CITY OF FRISCO PURCHASING DIVISION

Addendum #3 - Bid # 1012-017 LEBANON/WARREN ROAD TRAIL INFILL

"Lebanon Road & Warren Parkway - Trail Infill"

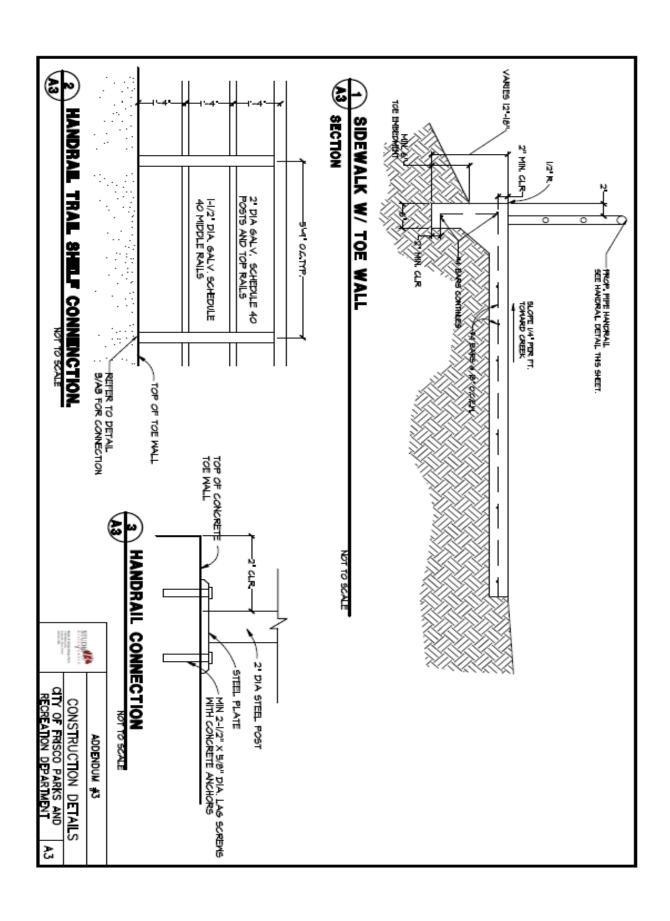
Handrail to have 2" diameter, schedule 40 top rail and post and 1-1/2" diameter, schedule 40 middle rails. Refer to detail 2/A3 attached with this addendum.

Revised toe wall detail to be variable depth between 12" and 18" with a minimum embed of 6". The wall width to be 6". Refer to detail 1/A3 attached with this addendum.

Revised handrail connection to be anchored to top of toe wall with lag bolts. Refer to detail 3/A3 below.
